<b>Office Action Summary</b>	<b>Application No.</b> 10/562,150	<b>Applicant(s)</b> KOBAYASHI ET AL.
	<b>Examiner</b> RYAN VARNUM	<b>Art Unit</b> 4118

**DETAILED ACTION**

**Annotated Fig. 2**

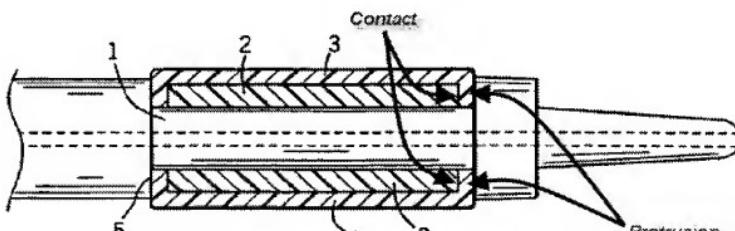
7. In re Claim 9, Baudino further discloses the outer member 3 (Fig. 2) is provided with a radially inwardly extending protrusion ("protrusion"; See Annotated Fig. 2 below) at the front end thereof and the back end surface of the protrusion is in contact with the front end surface of the inner member 2 ("contact"; See Annotated Fig. 2 below).
